Applicability of Figure 2 in DG-1263

Michelle Bales

Senior Reactor Systems Engineer
Office of Nuclear Reactor Research
U.S. Nuclear Regulatory Commission

Figure 2. An acceptable analytical limit on peak cladding temperature and integral time at temperature (as calculated in local oxidation calculations using the CP correlation)

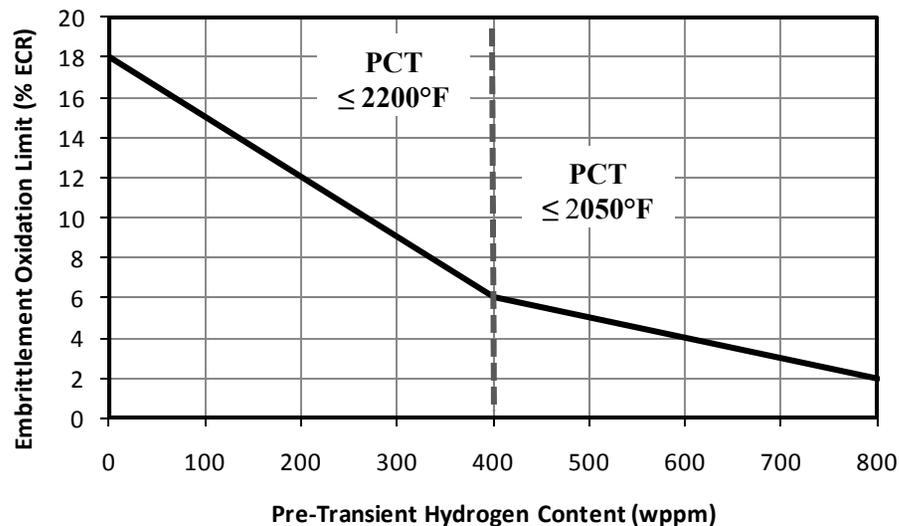
- The NRC received multiple comments regarding the applicability of this curve to new cladding alloys, particularly new cladding alloys for which alloy contents are similar to the alloy contents of the alloys tested.
- The NRC is considering the comments that proposed revisions to the draft guide to vary the extent of testing needed depending on the alloy contents of a proposed new cladding alloy.

- Adoption of Figure 2 should be allowed (*without testing was implied*) for alloys within the same family as those tested at Argonne. The definition of “family of alloys” could be zirconium alloys with Nb<1.5%, Fe<0.3%, Sn<2%, Cr<0.2%, Ni<0.2%, O >900ppm.

- Adoption of Figure 2 for new cladding alloys (*without testing was implied*) could be defined by the solubility of alloying elements in the beta phase.

- A discussion of what constitutes a “new alloy,” for the purposes of applicability of Figure 2, should be added to the RG.
- The research found no effect of alloy composition on embrittlement and there is no reasonable expectation that a limiting curve should be found at 1200C for another zirconium alloy that would be difference from the referenced figure. (*Adoption of Figure 2 for all zirconium alloys without testing was implied.*)

The NRC is considering introducing two distinct methodologies to demonstrate consistency with the existing database (i.e., adoption of Figure 2) for new cladding alloys. Assuming the reduction method and maximum fluence are the same as previously tested materials,

1. if the subject new alloy introduces an alloying element not present in the materials tested or the alloying content of an element is significantly different than the materials tested, then testing would include:
 - As-received (AR) material
 - Pre-hydrided material - every 100 wppm between AR & max [H] predicted at EOL
 - Irradiated material – at least 2 [H] levels; (1) within 50 wppm of max [H] predicted at EOL and within 50 wppm of $\frac{1}{2}$ max [H] predicted at EOL material

2. if the subject new alloy includes only the alloying elements present in the materials tested and the alloying content of each element is similar to the materials tested, then a reduced level of testing could be considered.
 - As-received (AR) material
 - Reduce pre-hydrided testing to only 2 [H] levels
 - Eliminate testing of irradiated material
